City of Portland, Oregon
Bureau of Development Services
Land Use Services

**NOTICE OF A TYPE II DECISION ON A PROPOSAL IN
YOUR NEIGHBORHOOD**

CASE FILE NUMBER: LU 10-141570 DZM
STOREFRONT REMODEL, PARKING LOT UPGRADES

Proposal: The applicant requests design review approval for a storefront remodel. The east elevation will have updated storefronts, an entrance canopy, entry lights, and 2 small projecting elements above 2 other storefronts. The primary building material, stucco, will be improved with new. The parking lot will be restriped for a maximum of 10 vehicles. The parking lot will also be upgraded to include required parking lot landscaping, required pedestrian connections and required bike parking. The only building signage proposed includes two internally illuminated individual letter wall signs, each measuring 38.82 SF in area – one will be centered over the main entry at the east elevation and one will be centered at the north elevation.

Super Supplements Portland Preliminary Site Layout Portland, OR

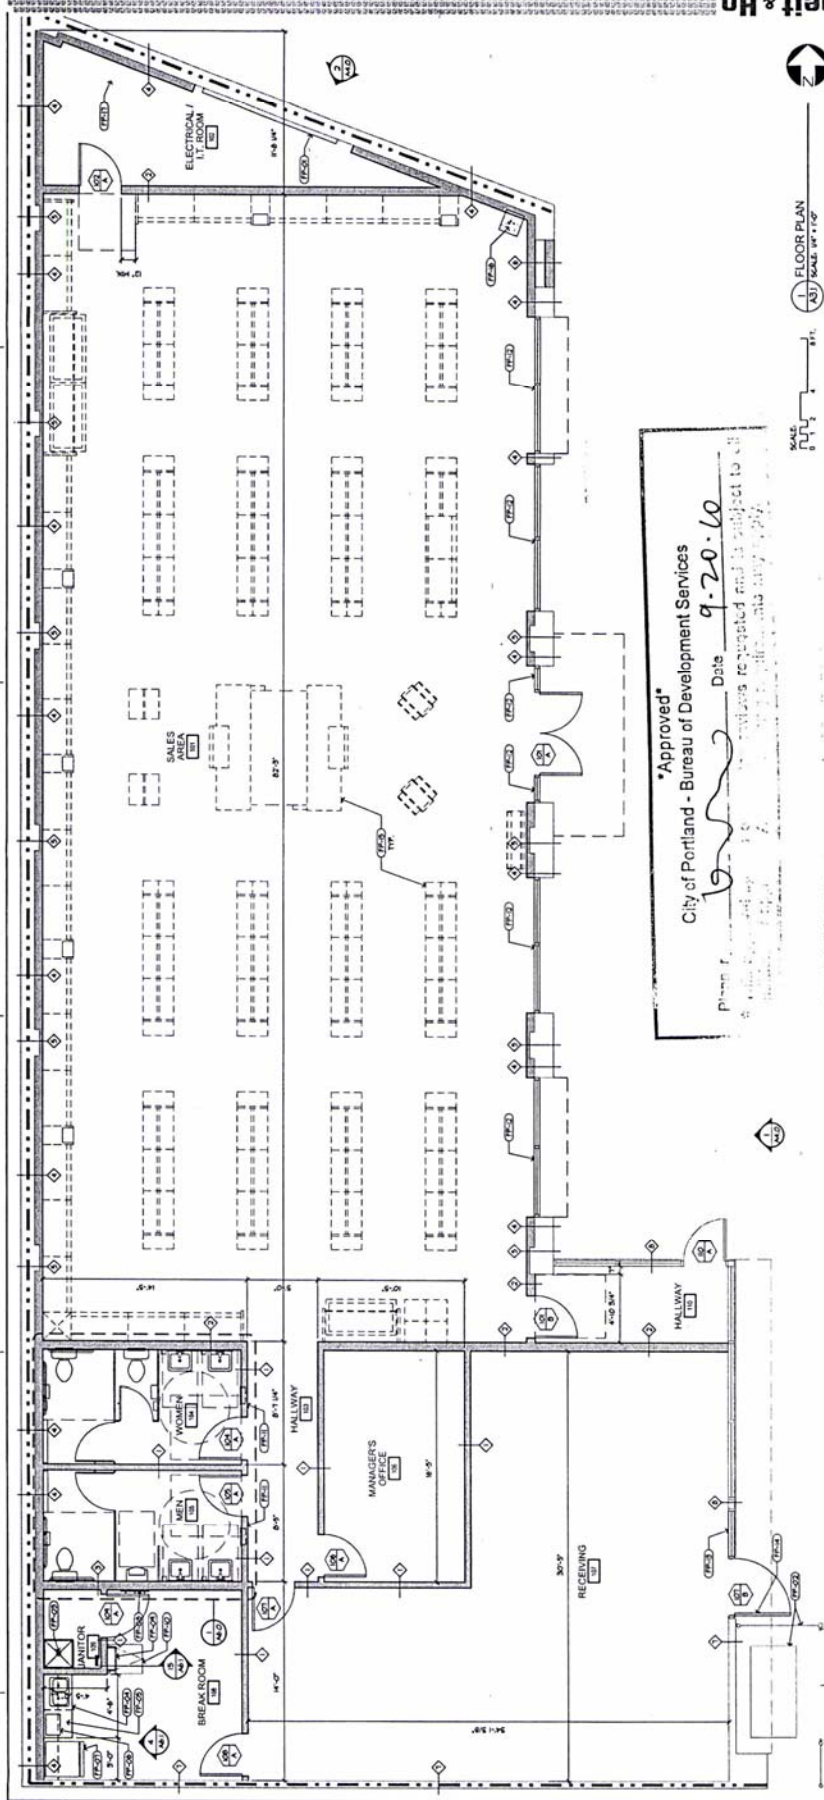
- B. All landscape areas shown on Exhibit C.1 must comply with (at least) the L2 standard of 33.248.020 B. All landscape areas shown on Exhibit C.1 must comply with installation and maintenance, including irrigation, listed in relevant sections of Chapter 33.248. Demonstration of compliance with this condition is required prior to the sign-off of building permits.

Job #: 10-108
 Date: 10-14-10
 Condition of
 Approval "B": A1
 (landscape area
 shown here not comply
 with (at least) the L2 standards of
 33.248.020 B. A1 landscape areas shown
 here must comply with installation &
 maintenance, including irrigation, of 33.248.

SCALE 1/8" = 1'-0"
EAST ELEVATION

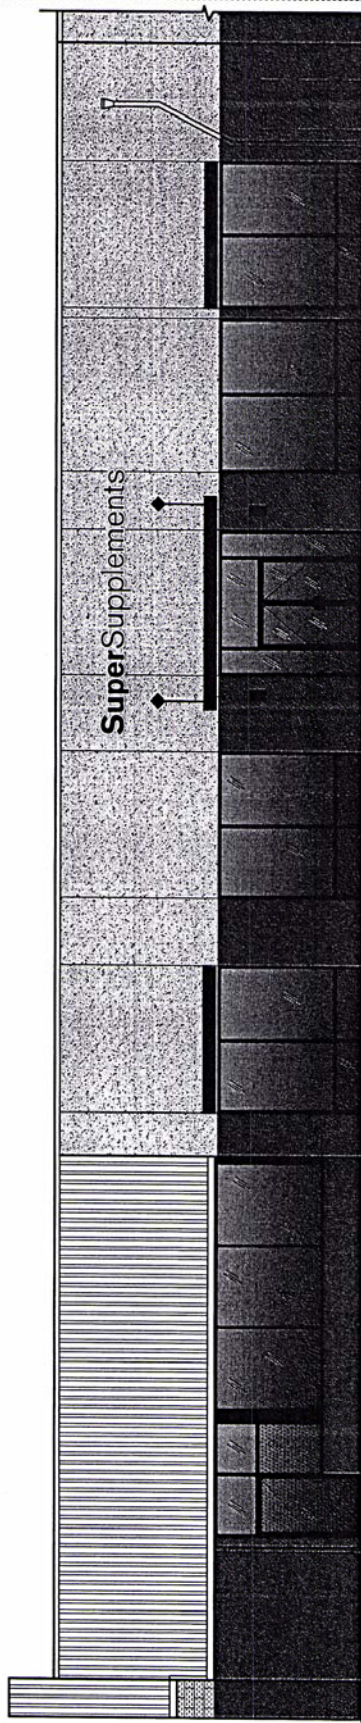
- C. All storefront glass (except areas depicted "EL-11" on Exhibit C.4) must be clear. Demonstration of compliance with this condition is required prior to the sign-off of building permits.

Condition of Approval "c": All storefront glass (except areas depicted "EL-11" on 201 C. 6) must be clear.

Elevation View - Scale: 1/2" = 1'-0"

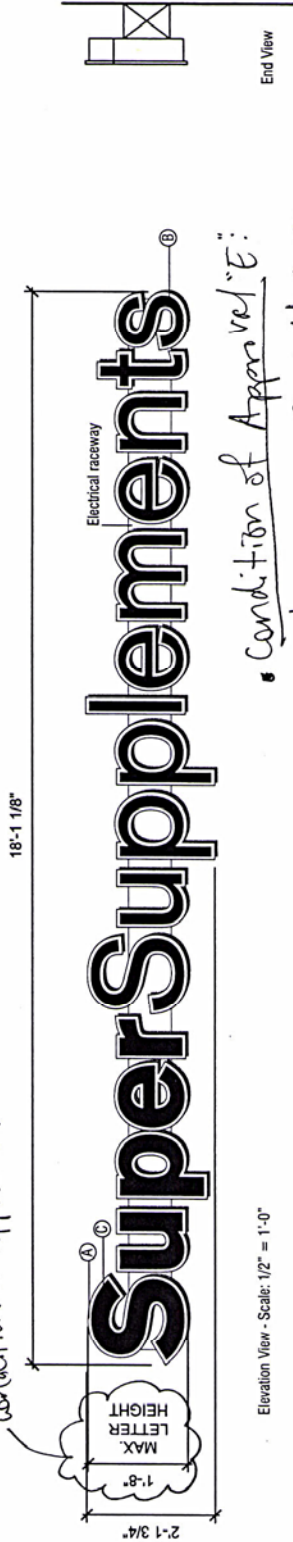
As typically required through Design Review, the electric raceway elements to power the signs, should be located inside the building (not on the building's exterior skin as depicted in the submitted sign drawings). The façade would then be visible between the letters, the sign would appear more integrated with the building, and, overall, the sign would have a lighter touch on the building wall. **Condition of approval 'E'** will require that the raceway for both signs be located inside the building. For the same reasons, a **condition of approval 'F'** will require that the conduit for both signs not be visible beyond the outline of both signs. These specifically considered aspects of the signs' attachment to the building exterior (raceway and conduit) help integrate the sign by minimizing and/or eliminating views of mechanical aspects of the sign technology, leaving only the actual lettering exposed on the exterior of the building.

- D. No individual letter will be greater than 20" in height for the proposed wall signs and any future copy changes of the proposed wall signs. Demonstration of compliance with this condition is required prior to the sign-off of sign and building permits.

- E. The raceway for both signs will be located inside the building. Demonstration of compliance with this condition is required prior to the sign-off of sign and building permits.

- F. The conduit for both signs will not be visible beyond the outline of both signs. Demonstration of compliance with this condition is required prior to the sign-off of sign and building permits.
- G. No field changes allowed.

Condition of Approval "D":

Condition of Approval "E":

"The raceway for both signs will be located inside the building."

Condition of Approval "F":

"The conduit for both signs will not be visible beyond the outline of both signs."
